TECHNICAL SERVICE BULLETIN

REFERENCE: SMU250KTST

SUBJECT: ALTERNATOR WHINE / PTT POPPING

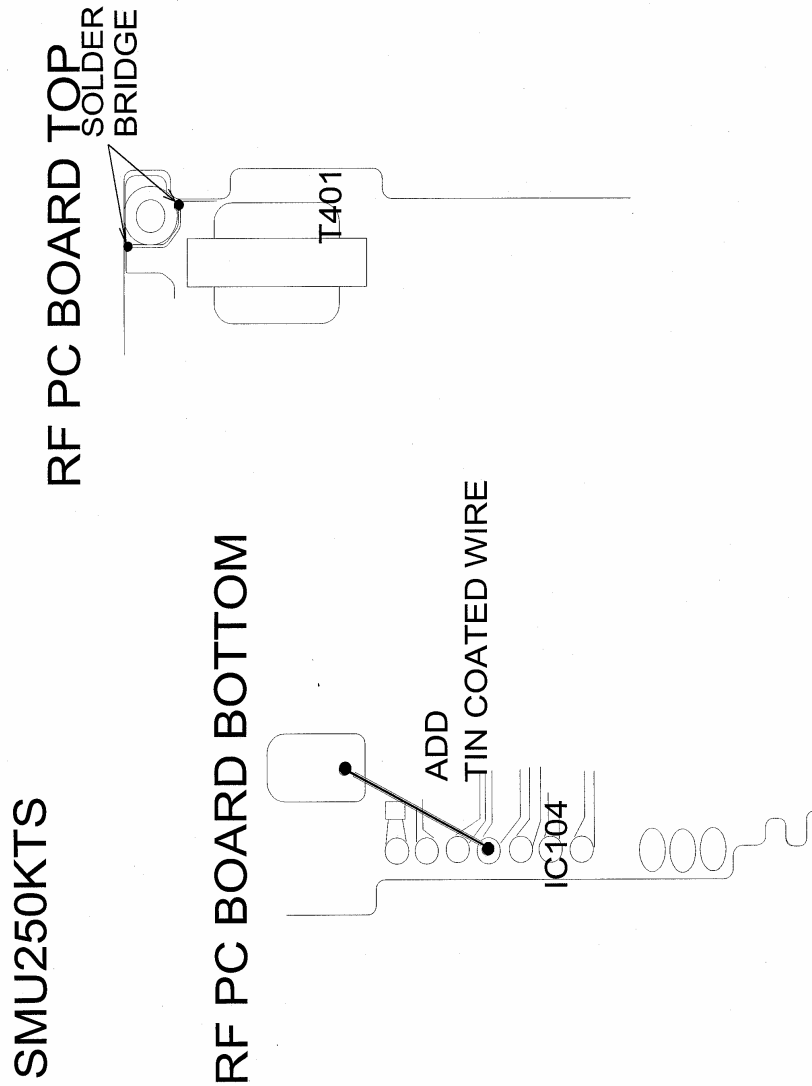
GENERAL: This bulletin pertains to models with RF PCB version PD751AC, which is found in units with serial numbers 04xxxxxx and higher. Due to some of the changes in this new circuit board you may notice an increase in alternator noise, or popping during PTT. The following modifications can be made to improve operation.

- a. Change R168: 47 ohms to 150 ohms (BRFC011544Z)
- b. Change R133: 22K ohms to 15K ohms (BRFC011534Z)
- c. Add JUMPER WIRE between No.4 pin of IC104 and T401 CASE GND.
- d. Connect GND PATTERN near by T401 by soldering.

See page 2 for c and d locations.
